Well Name: CO 3 34 FEDERAL	Well Location: T25S / R32E / SEC 10 / NENW / 32.150076 / -103.66649	County or Parish/State: LEA / NM
Well Number: 627H	Type of Well: OIL WELL	Allottee or Tribe Name:
Lease Number: NMLC061936	Unit or CA Name: COTTON DRAW UNIT	Unit or CA Number: NMNM70928X
US Well Number: 3002554208	Operator: CHEVRON USA INCORPORATED

Type of Action: APD Change

Procedure Description: Chevron U.S.A. Inc. is proposing to sundry CO 3 34 FEDERAL 627H in Cotton Draw to revise the well names, C102s, 9-point plans and directional drilling plan. Please note that some of the changes below have already been approved by the BLM but due to NMOCD records these changes need to be explicitly called out and approved by the BLM again. Well Name Change Current BLM Name: CO 3 34 FEDERAL 627H o Current NMOCD Name: CO 3 34 FEDERAL 306H o New BLM/NMOCD Name: CO 3 34 FEDERAL 627H Note:(the current NMOCD name is being included to correct NMOCD records) • C102 Changes o Pool Code: Changing 96715 to 98270 o Pool Name: Changing WC-025 G-06 S253209L; Bone Spring to WC-025 G-08 S253216D; Upper Wolfcamp o Surface Hole Location: Changing the north call from 790' to 784' o Bottom Hole Location: Changing

CO Pad 627

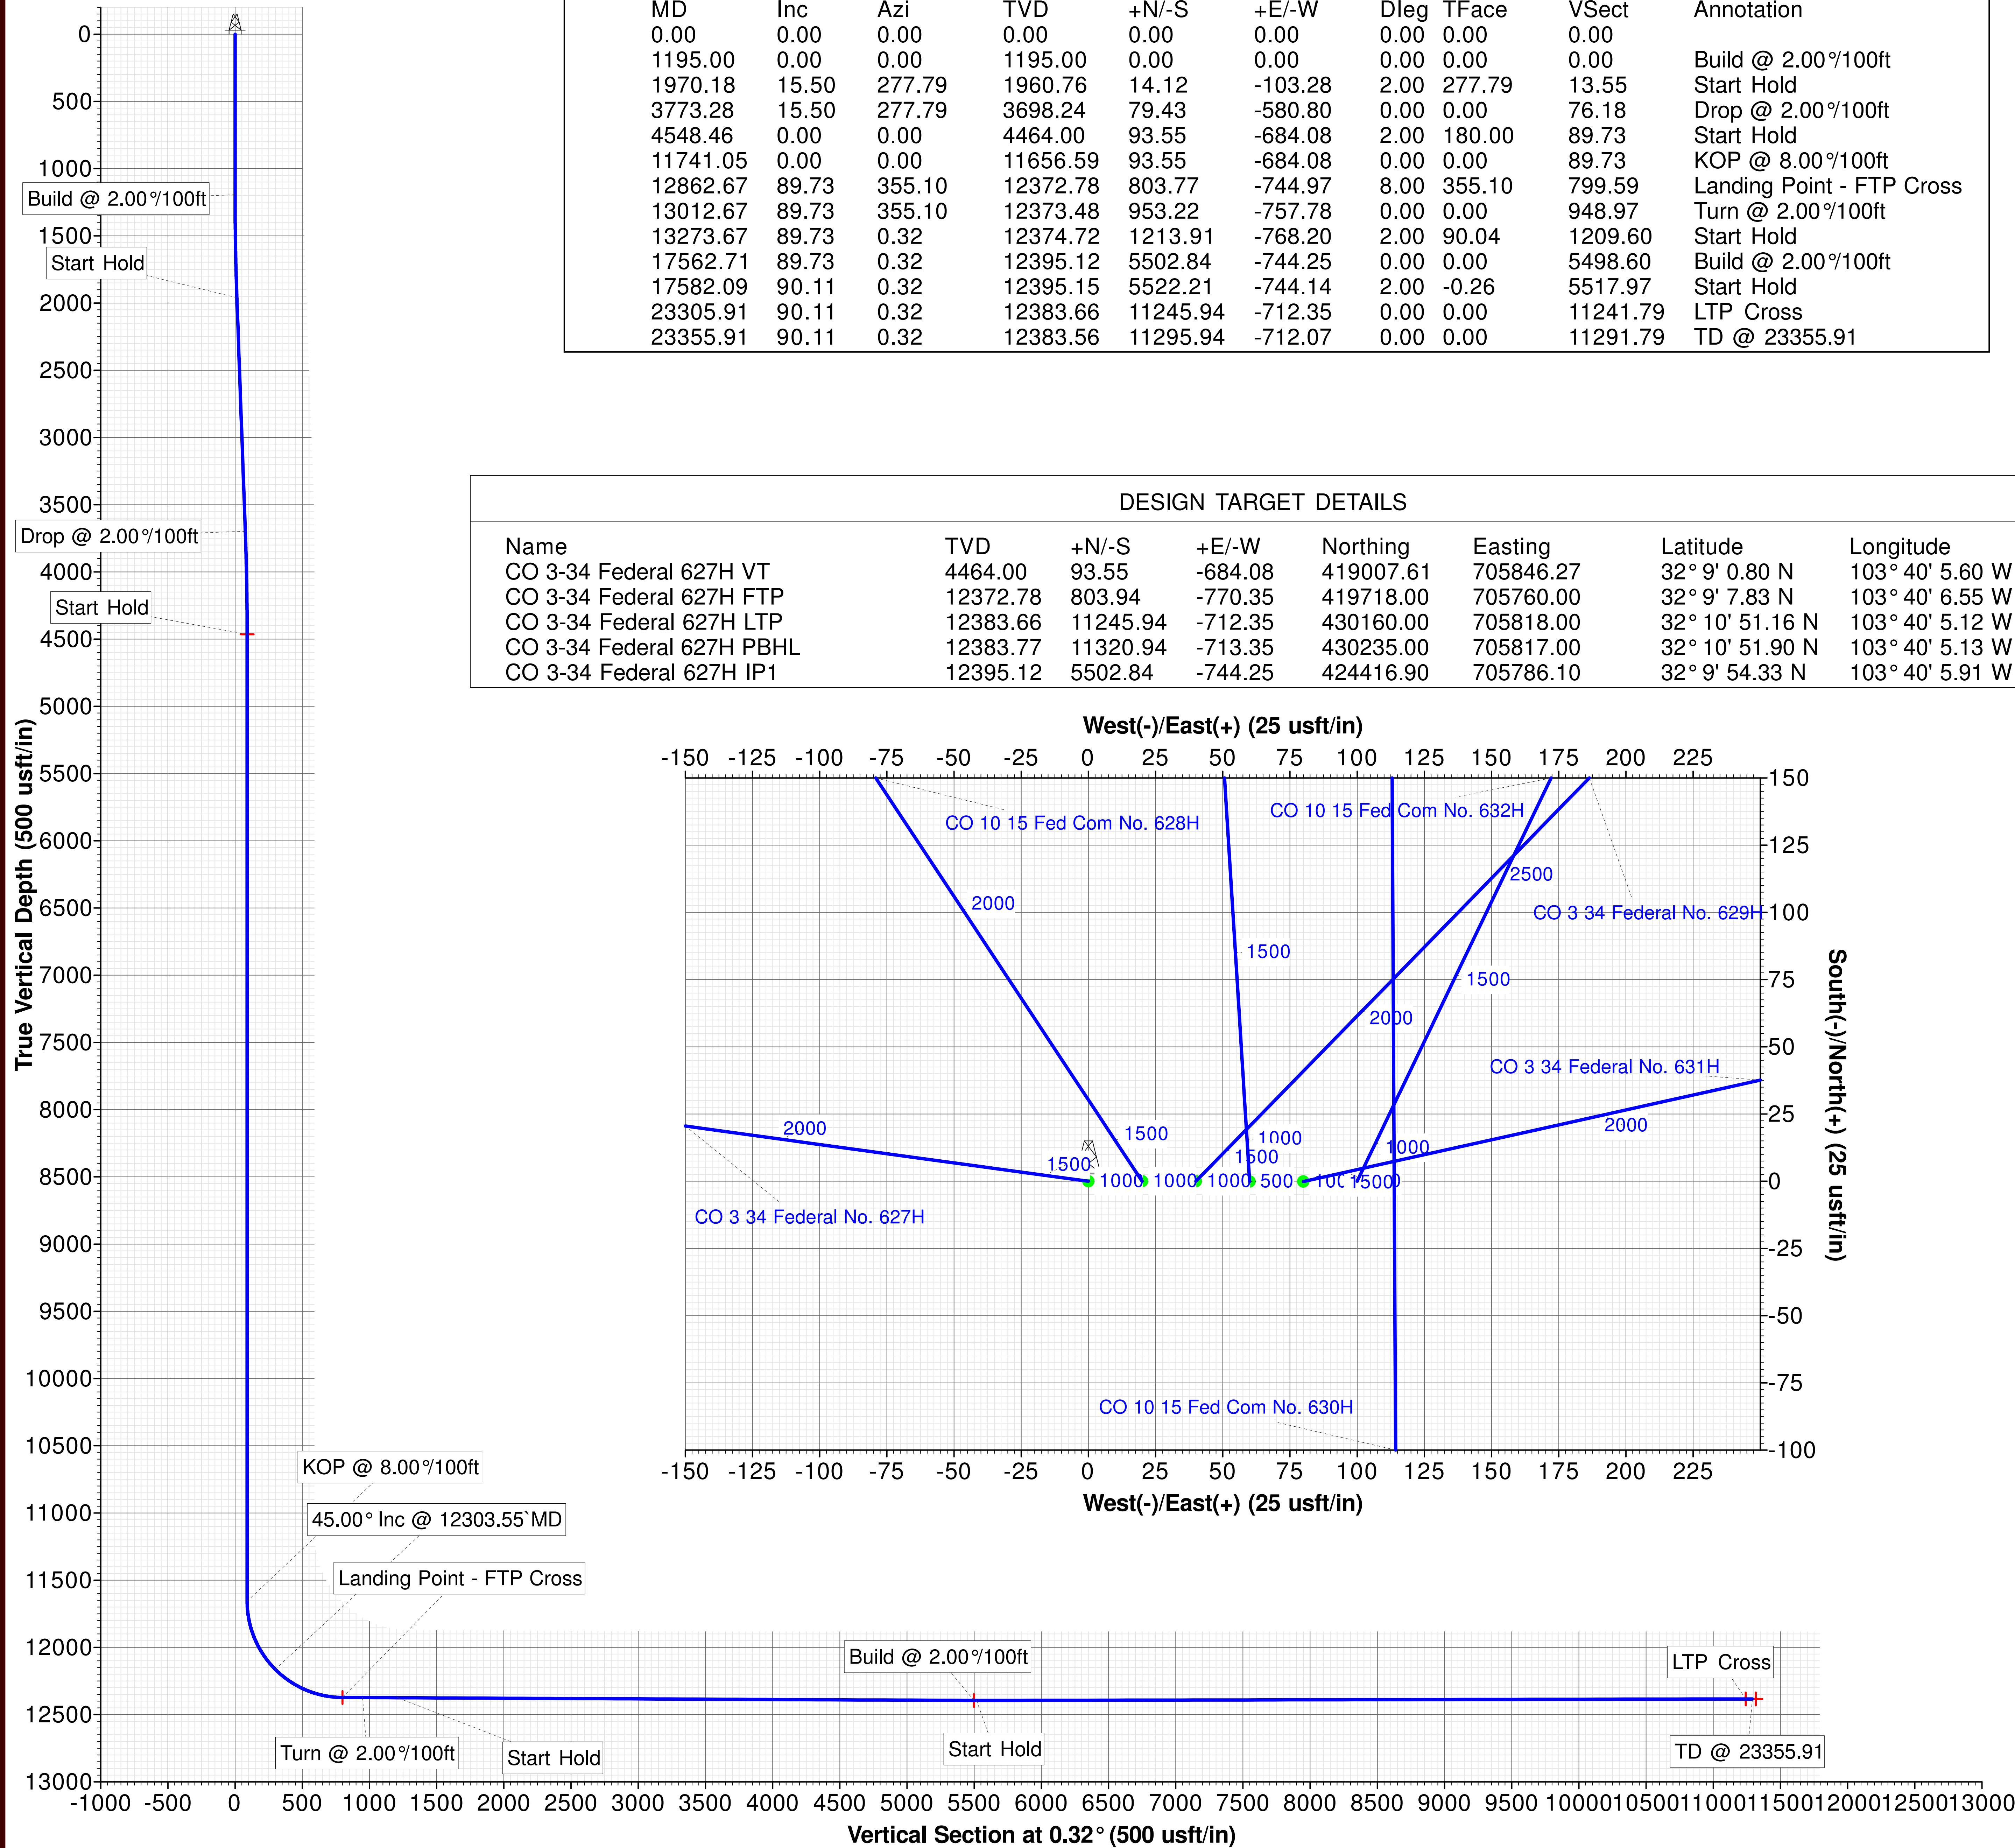
- **Updated Directional Drilling Plan**
